Service Bulletin

SAFETY RECALL

2014 CTX700ND ABS MODULATOR REPLACEMENT

PREVENTING BRAKE FLUID LEAKAGE (Step 10)

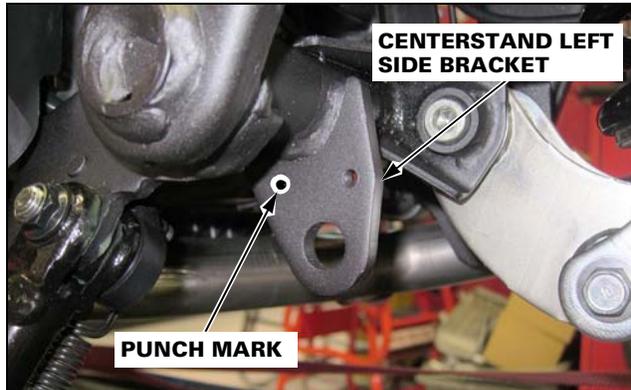
1. Connect a bleed hose to the front caliper bleed valve.
2. Loosen the bleed valve and then pull the front brake lever fully against the handlebar. Secure the lever against the handlebar with a band or zip-tie and close the bleed valve.

This will help prevent the brake fluid from leaking out of the reservoir during ABS modulator replacement.

PARTS IDENTIFICATION

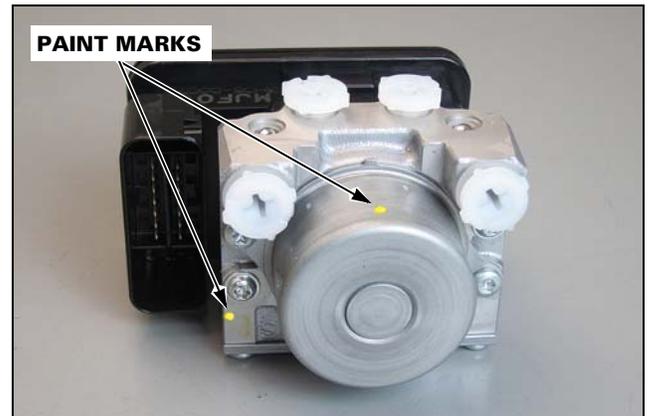
Be careful not to mix up the defective and replacement parts. The as packaged countermeasure part is identified by two yellow paint marks as shown. Use care during unpacking and installation as the the paint marks are easily wiped off.
